Validation/Field Installation Verification  
Test Report  
For  
Nebraska Public Power District  
Plant Management Information System

SAIC-86/1500&264&0  
March 12, 1986

Validation/Field Installation Verification

Nebraska Public Power District

Figure 8-2. Display L2.1.1, Reactivity Control (Bar).

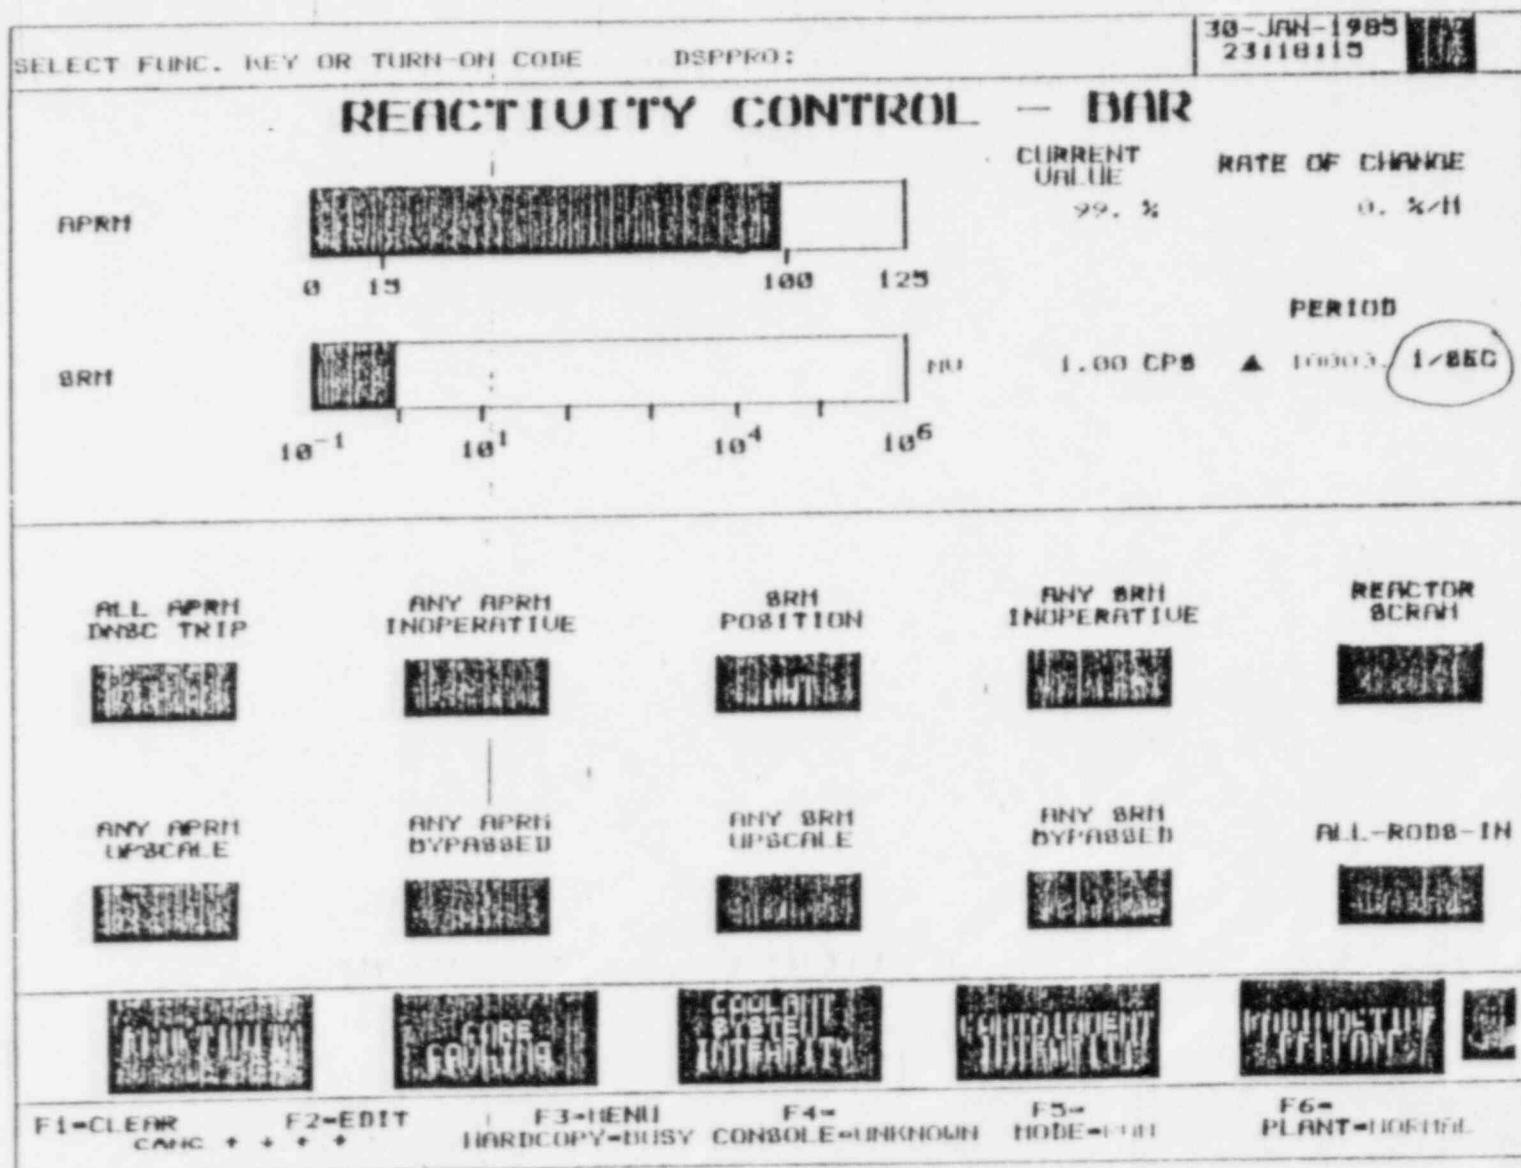
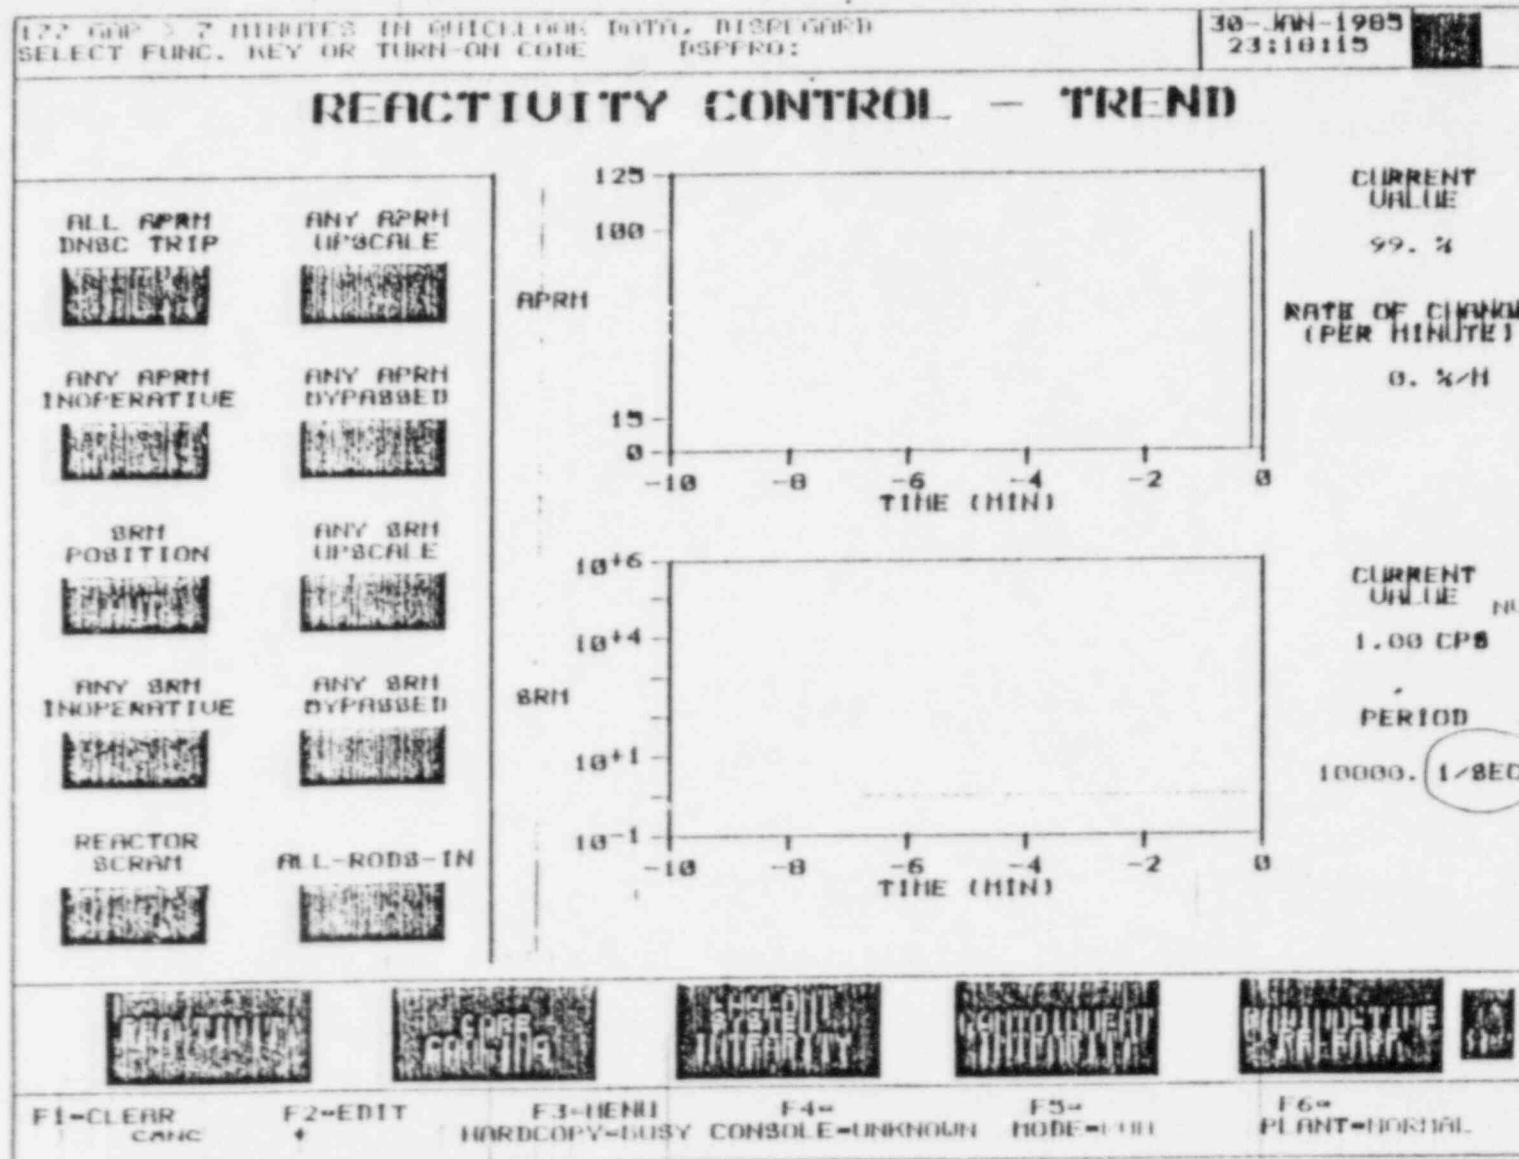
REVIEWER'S COMMENT	SERIAL NO.: 4
PROJECT: NPPD V&V	DATE: 02/20/85 and 5/3/85 and 1/6/86
V&V TASK: VALIDATION TESTING	ISSUED BY: A. F. LEXA
TEST(S) UNDER REVIEW:	<p>Nebraska Test Procedures, Document No. 501-8500102-02 forwarded by Pate to Lexa, memo dated 3/21/85</p> <p>- FAT TEST #61 - SPDS</p>
QUESTION OR ANOMALY:	<p>Reactor Period Units -</p> <p>The units used for SRM period (on the Reactivity Control-Bar and Trend Displays) was expressed in Sec -1. This should be seconds. Both the display and design documents should be revised. See attached displays.</p> <p>NOTE: During FAT the display was changed, however, no test variance report was issued. This comment should ensure complete resolution.</p>
COMMENTS:	<p>1/6/86 - Delete This Comment. Site tests confirmed correct units for reactor period.</p>

# RPU WATER LEVEL

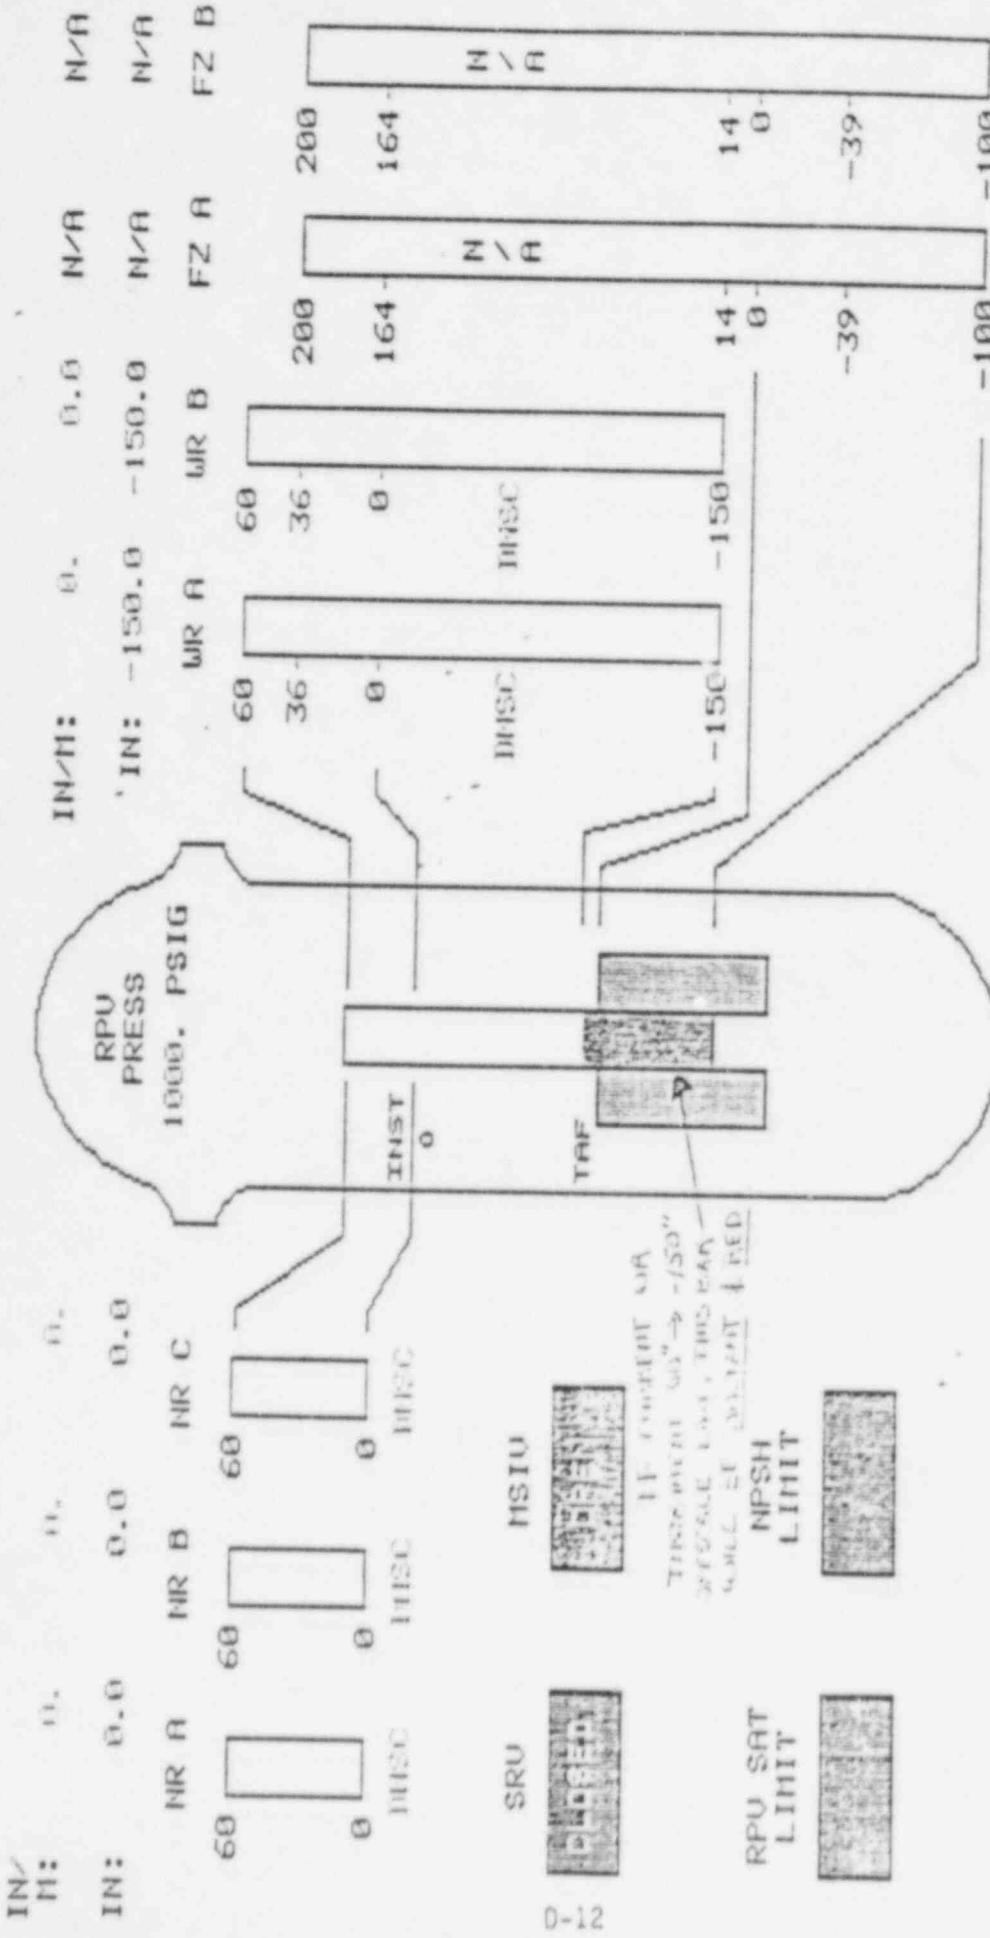
- FAT TEST #61 - SPDS	
QUESTION OR ANOMALY:	
Wide Range RPV Level -	
The RPV water level display has provisions for a new wide range (200 to -100") instruments. The current display will provide an unchanging red bar level indication if the existing level instruments go off scale low. See attached display.	
Displaying a water level bar not driven by live instrumentation could be confusing.	
To avoid this confusion, it is recommended that no bar be shown until the new instruments are installed.	
COMMENTS:	
1/6/86 V&V TEAM COMMENTS	
The V&V Team recommends a human factors review of the above concern. Disposition is left to NPPD and the developers.

# RHR PUMP NPSH LIMITS

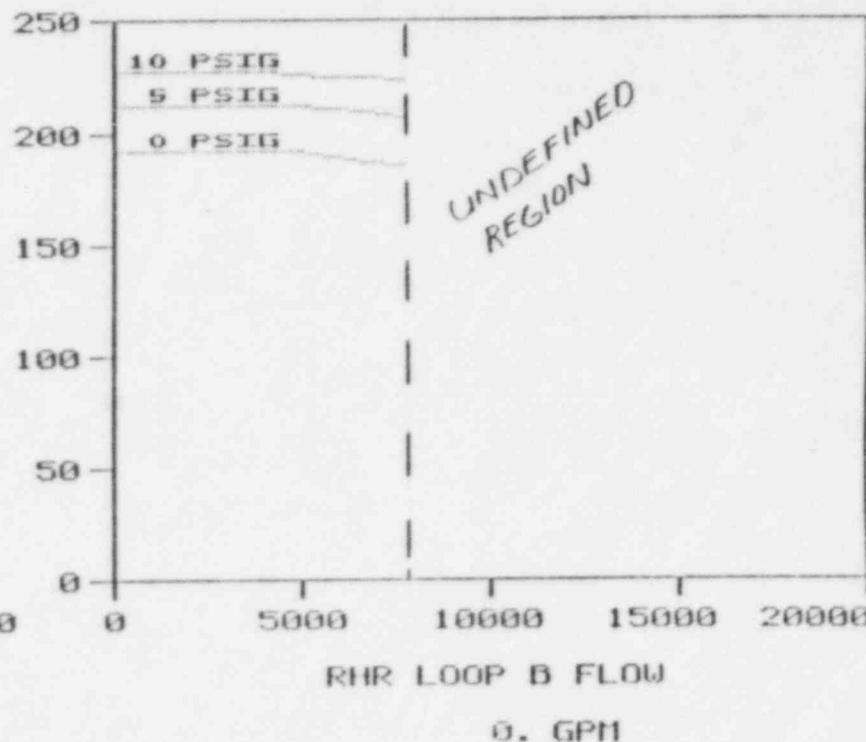
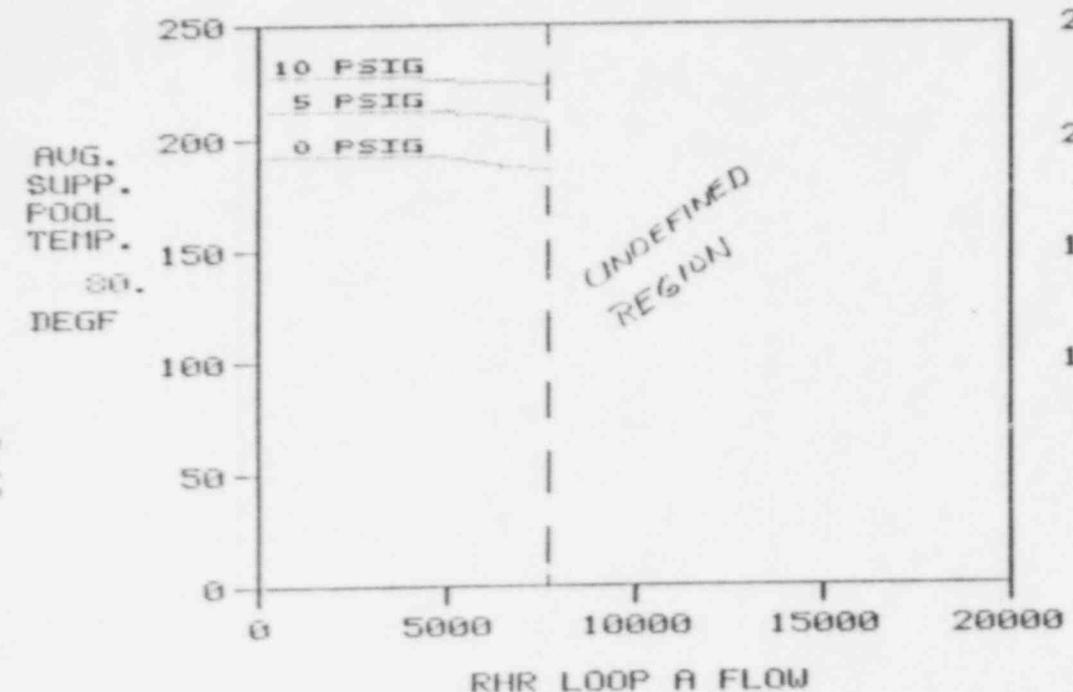
**NOTE:** The logic diagram for the NPSH Limit EOFGI is shown on Figure 9-13, page 9-47. The point values being input to this calculation do not give the results predicted by the logic shown in the diagram.

The first decision box checks the health of these points. Since two of the points are not healthy, the result of the check should be a NO from that box. The NO path leads to a magenta EOPSI box. Since the EOPSI (RPV WATER LEVEL) is red, the program logic is not correct.

The next two decision boxes check the health of SPDS0063 and the health of SPDS0045. Both are healthy which results in a yes from these two boxes. The next four boxes check to determine whether or not the point  $f(X,Y)$  is greater than the Limit Curves for the Core Spray and RHR pumps. The results from these decisions are a NO, which leads to the green EOPSI box. However, since the EOPSI is red, the logic again is questionable. Correcting the first logic error could eliminate this problem.

This problem is documented as SSCR034, and was discussed during the meeting at CNS. Per Lobner's notes, dated 11/6/85, part I of II, item c, SAIC will verify the software for the NPSH limit EOPSI.

## REACTIVITY CONTROL - TREND

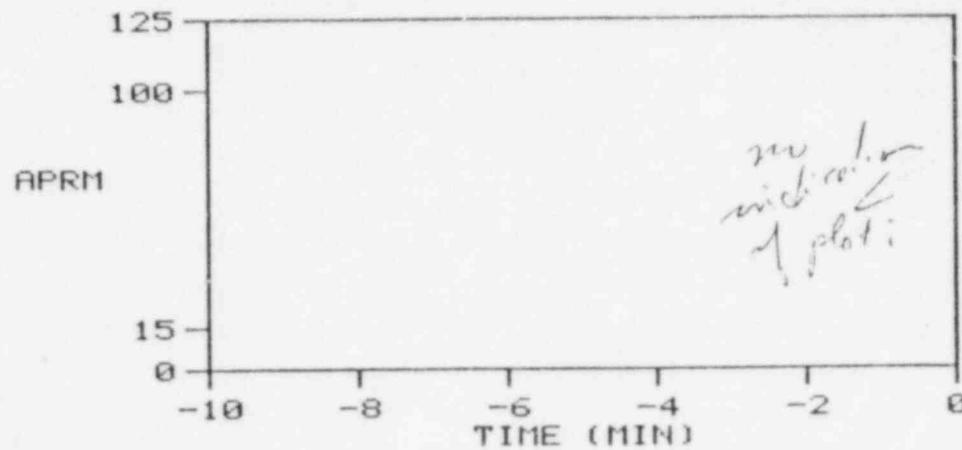
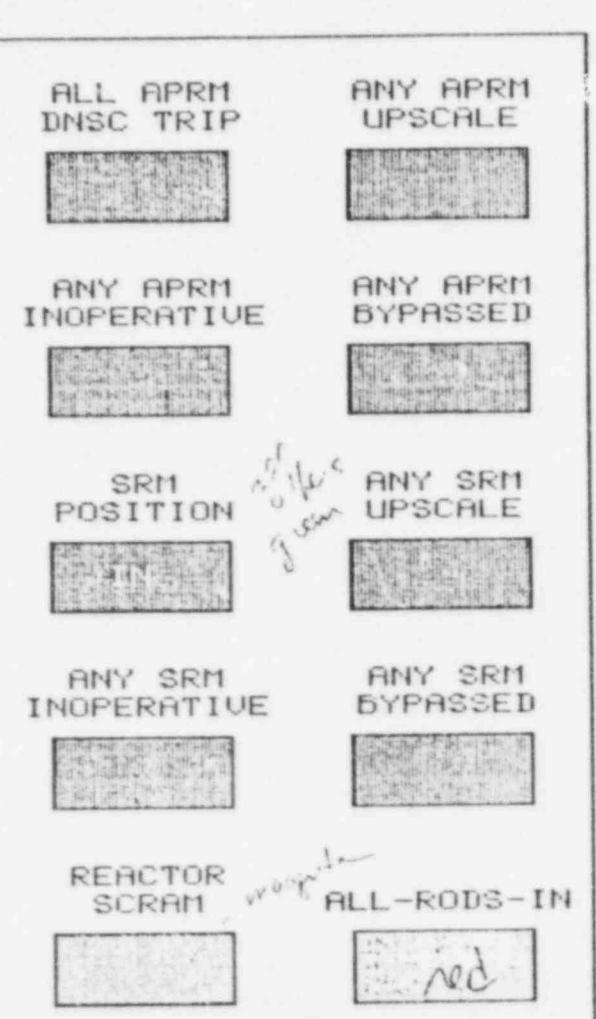
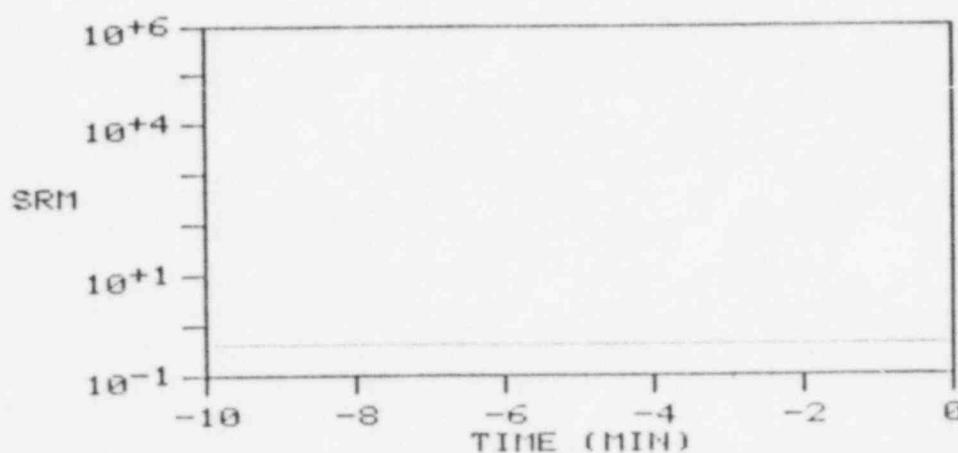
During the V&V visit to CNS on 8/20, 21/85 plant conditions did not allow a complete test of this function. The following tests are recommended:		
<ol style="list-style-type: none"> <li>1) Insert a value for SPDS0014. A constant value should yield a startup rate of zero. What happens to reactor period (divide by zero?)</li> <li>2) Check the scan rate for SPDS0087. Is it a 1 second scan? If not the algorithm won't work.</li> <li>3) If possible a ramp for SPDS0014 should be inserted and the reactor period calculation checked.</li> </ol>		
COMMENTS: (SEE SHEET 2 OF 2)
